## THE MUNICIPALITY OF THE VILLAGE OF LIONS BAY

RFP: Bayview Steel Superstructure, Timber Deck Driveway Bridge Rehabilitation

### **Document Title: ADDENDUM 2**

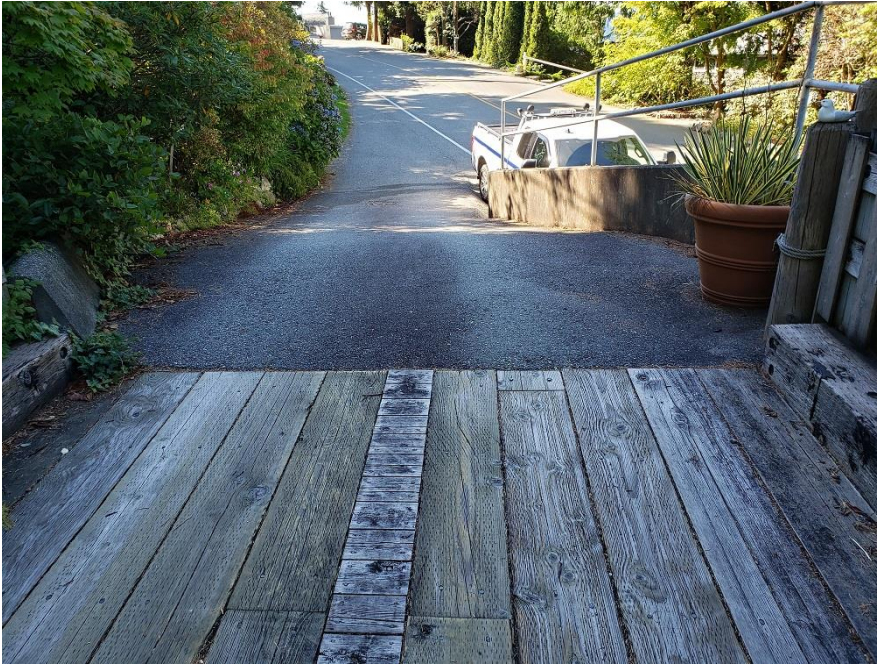
1. The Municipality has received inquiries related to the “Reconstructing a piece of the modular block wing-wall at the north east corner of the bridge with a cast-in-place concrete wall” from page 11 of the tender document.

**Response:** The following photo depicts the gap between the North abutment backwall and the modular block wingwall causing loss of backfill from behind the abutment backwall:

The loss of backfill is causing a cavity beneath the north approach apron of the bridge and can be seen in the photos below of the approaches. The repair will need to prevent this loss of backfill and stabilize the approach apron.
